# Monthly Specification Update

Intel® Server Board S5520UR

*Intel Order Number E69054-001*

**March 2011**

**Figure 1. Removing the Heatsink**

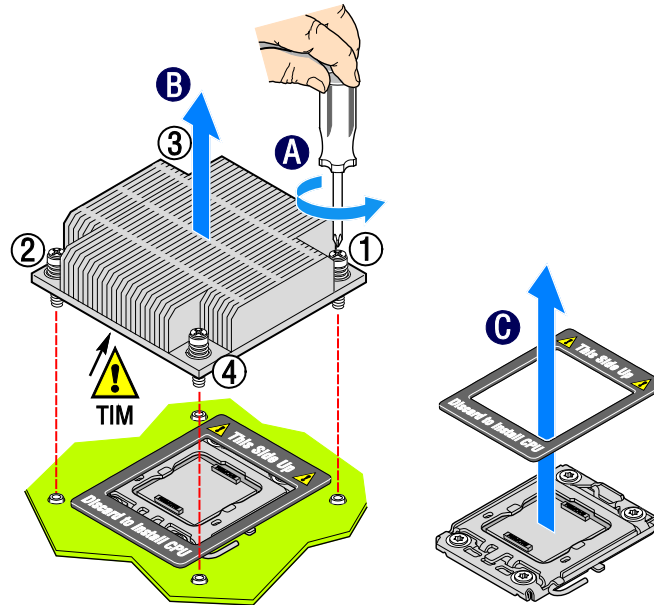
### 1. Proper Heatsink Installation and Removal Instructions are missing from Service Guide

**Problem:** The current documentation does not properly describe the installation and removal of the heatsink. Careful insertion and removal of the heatsink is required to prevent damage to the heatsink screws or backplate.

1. Loosen the four captive screws on the heatsink corners in a diagonal manner according to the numbers shown in figure 1 as follows:
  - Starting with the screw at location 1, loosen it by giving it **two rotations** in the anticlockwise direction and stop. (**IMPORTANT:** Do not fully loosen.)
  - Proceed to the screw at location 2 and loosen it by giving it two rotations and stop.
  - Loosen screws at locations 3 and 4 by giving each screw two rotations and then stop.
  - Repeat steps 1a through 1c by giving each screw two rotations each time until all screws are loosened.
2. Do one of the following:
  - If removing the heatsink for the first time, do the following:
    - i. Lift the heatsink from the board.
    - ii. Remove and discard the spacer (see letter “C” in figure 1).

- If a processor is already installed, do the following:
  - i. Twist the heatsink slightly to break the seal between the heatsink and the processor.
  - ii. Lift the heatsink from the processor. If it does not pull up easily, twist the heatsink again. Do not force the heatsink from the processor. Doing so could damage the processor.
